**Ferret
Exploration
Company of
Nebraska, Inc.**

Enclosed please find corrected replacement pages for the Application and Supporting Environmental Report for USNRC Commercial Source Material License. Please replace the original pages with the corrected pages. These changes were made as a result of the NDEC completeness Review.

ERRATA SHEET
DEC Completeness Review

Figure 4.9(B)-1

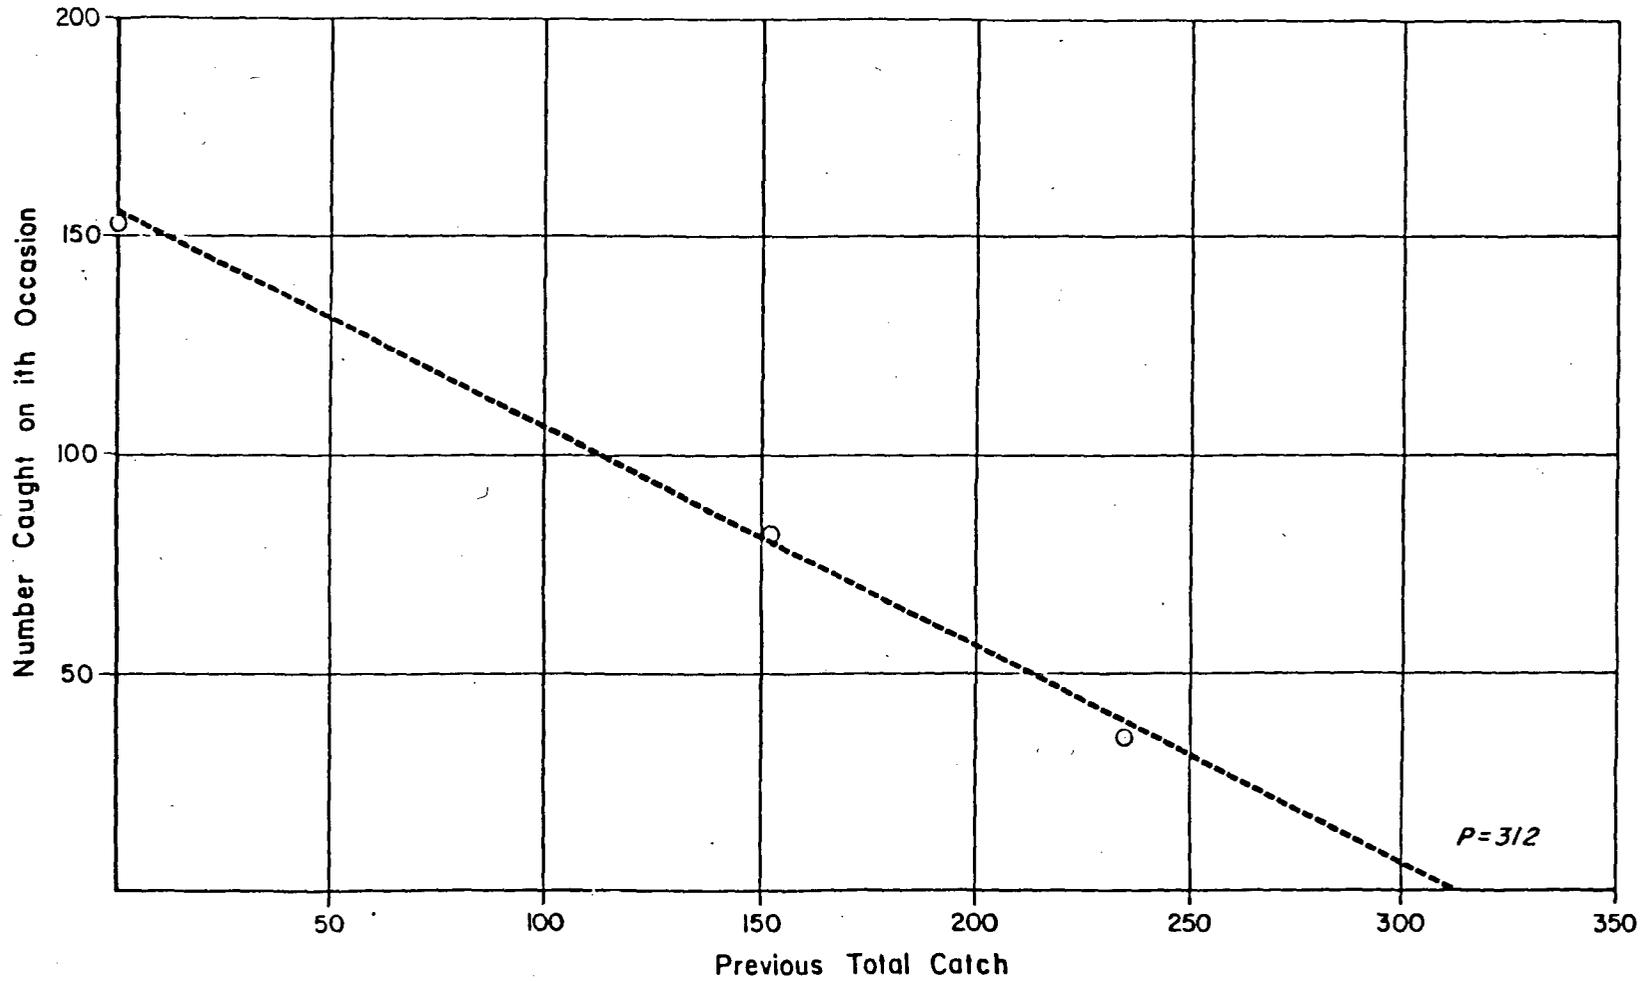
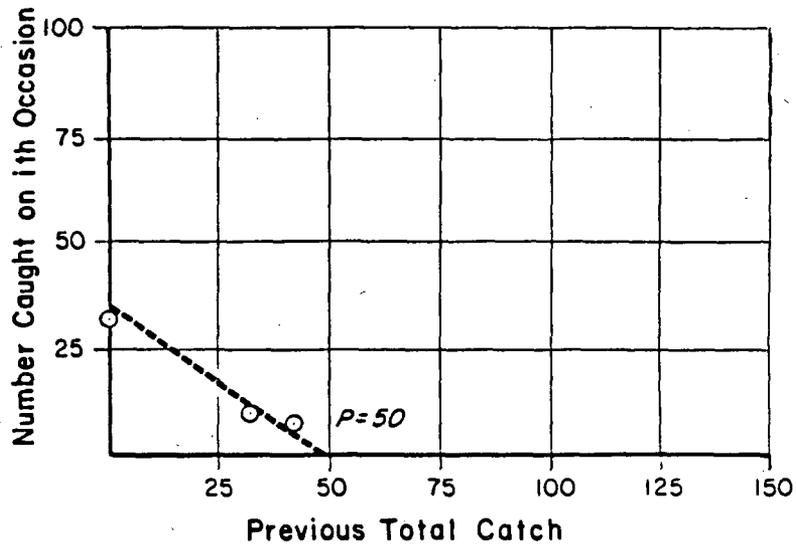
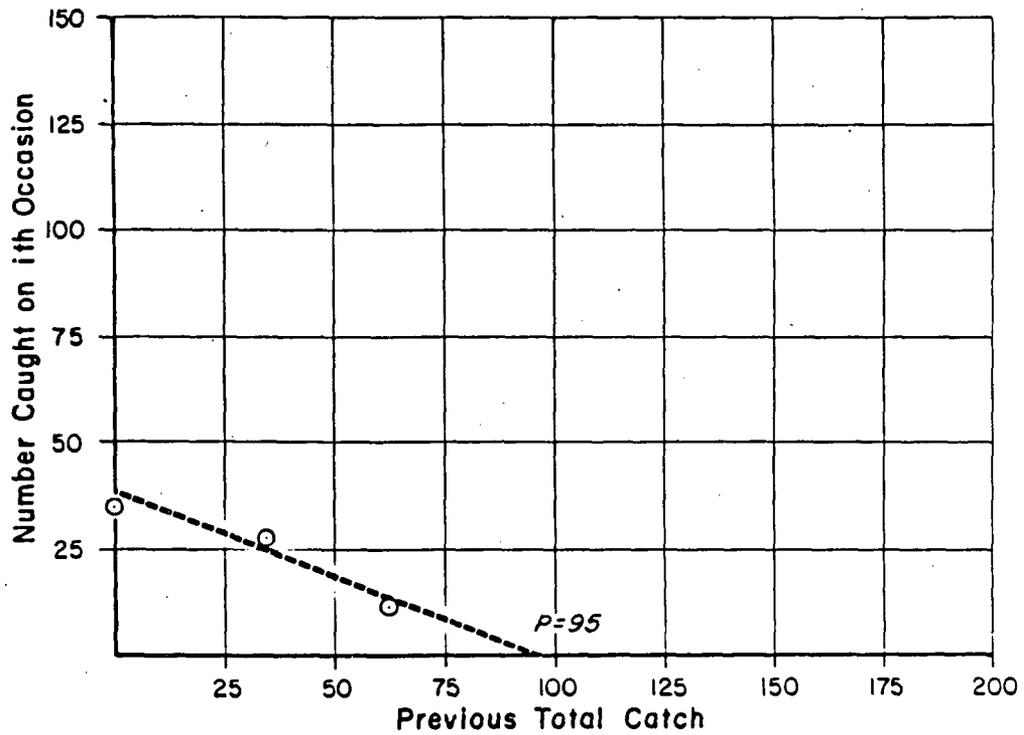
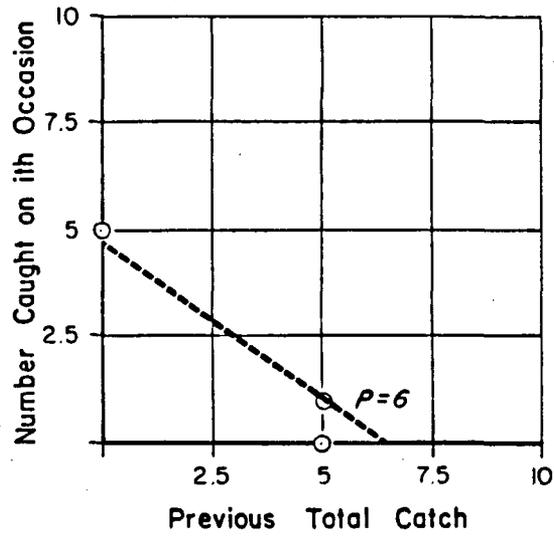
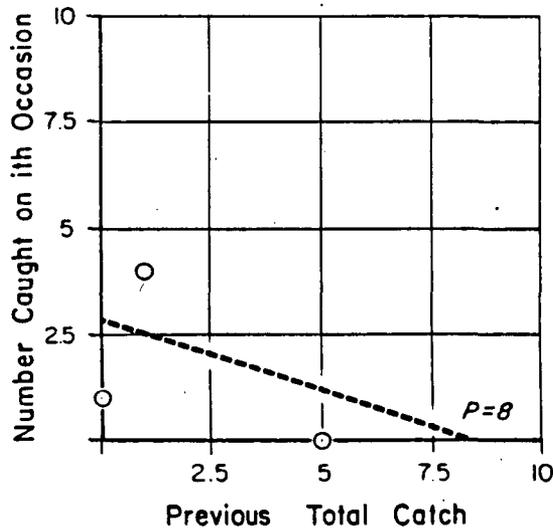
1. Fish population estimate data collected at Stations W-1 and W-3 on November 2, 1983, have not been included in the application. At the top of Page 4.9(113), the fish population estimate data collected on November 2, 1983, is stated to be in Appendix 4.9(B) of the application. Appendix 4.9(B) needs to be added to the application.

Appendix 4.9(B) has been included to be added to the permit application.

REV	BY	DATE	FERRET OF NEBRASKA, INC.	
1	DL	2/2/82	CROW BUTTE PROJECT	
2	DL	1/25/83	Dawes County, Nebraska	
3	BC	2/16/88	Typical Cement Basket Completion for Monitor or Injection/Production Wells	
			PREPARED BY: F.E.N.	
			DWN BY: JC	DATE: 8/87
				FIG. 10.2-1

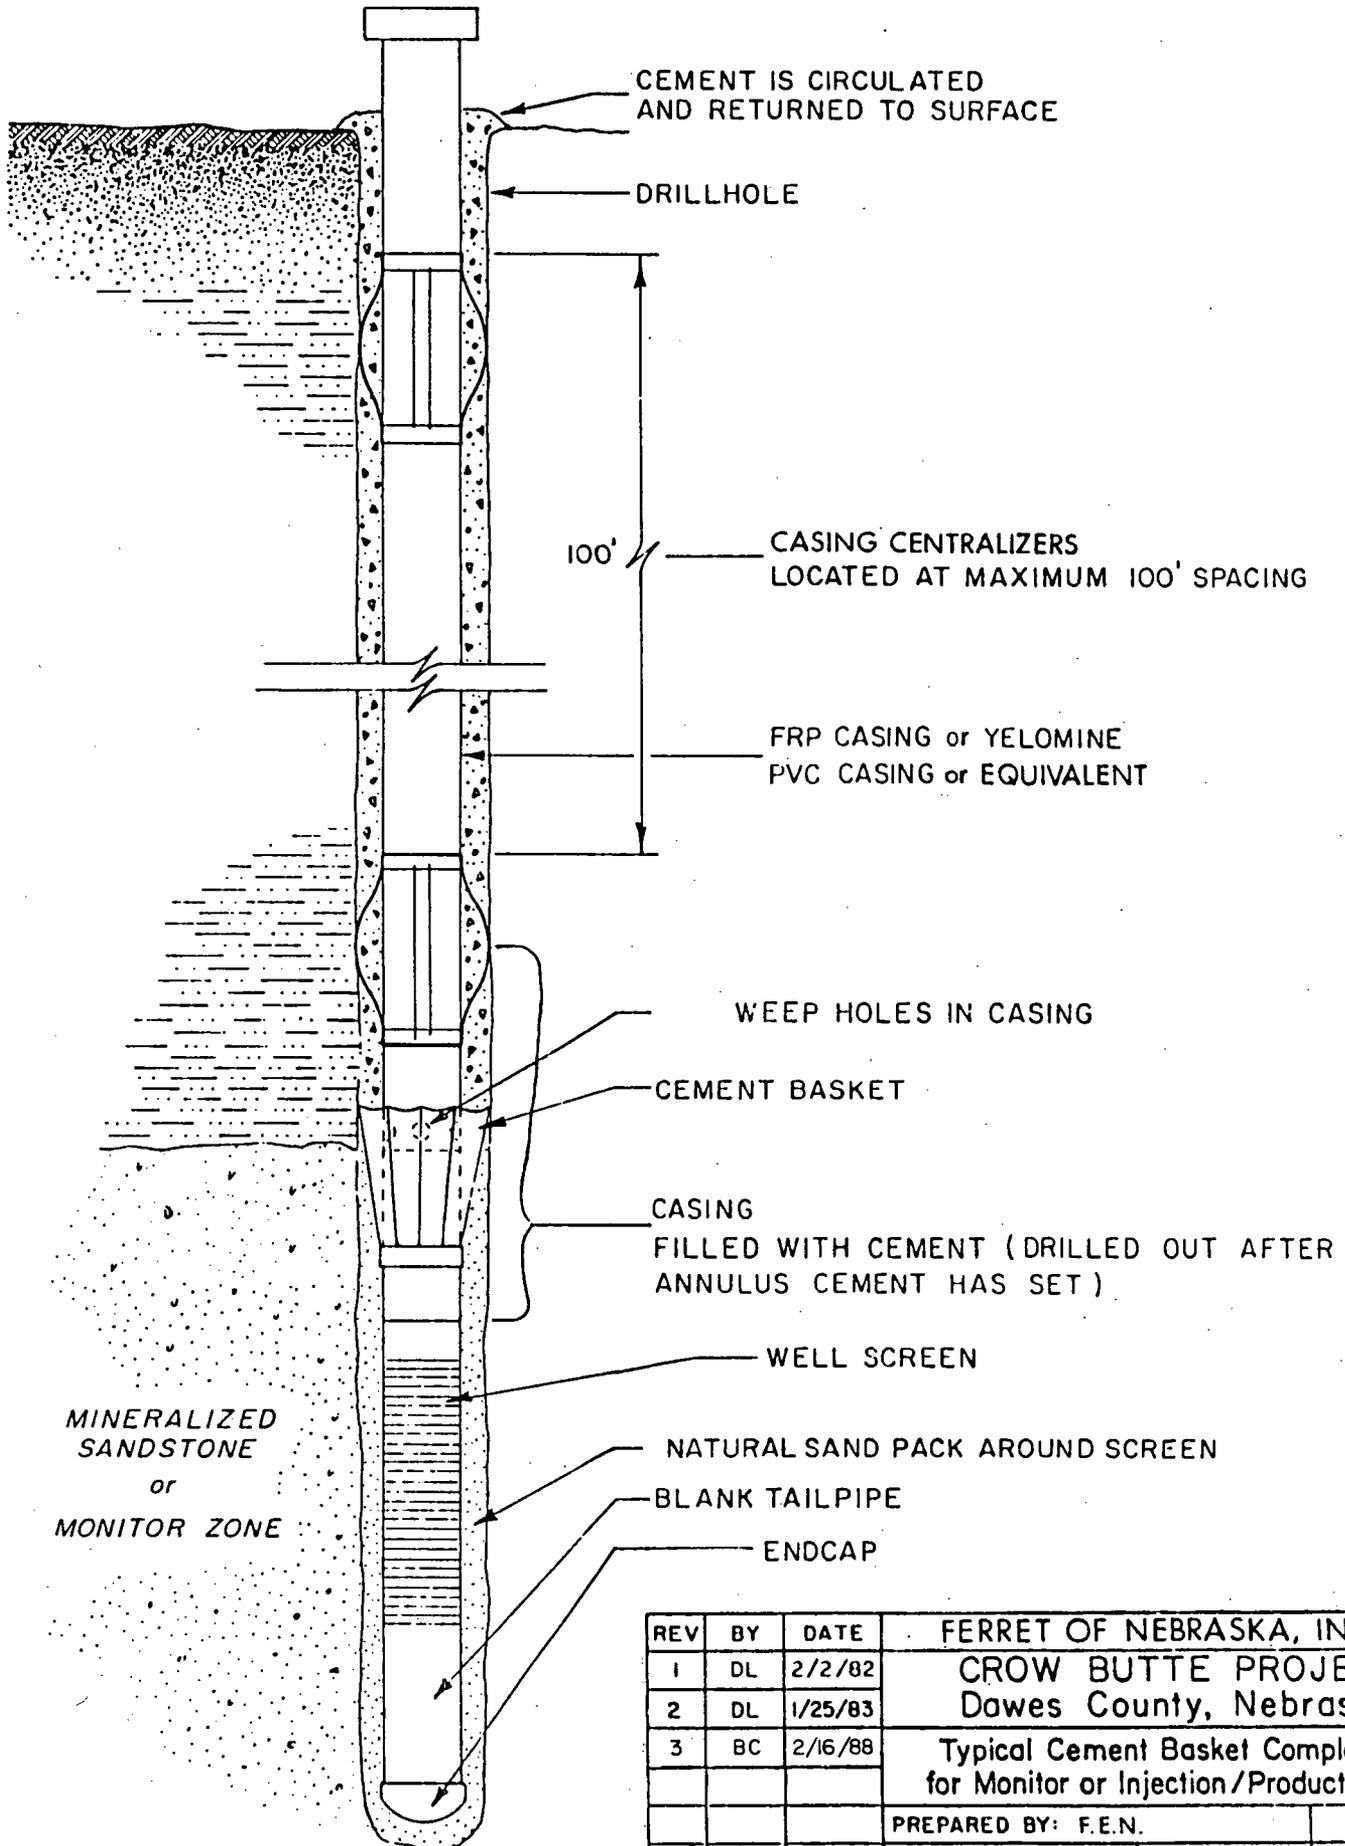
| | 10. | Corrected page 8.0(1) and Figure 10.2-1 and 10.2-2 attached |

This is natural sand packing that is developed during well clean-up. A clarification has been added to the text in 8.0 and on the Figures 10.2-1 and 10.2-2.
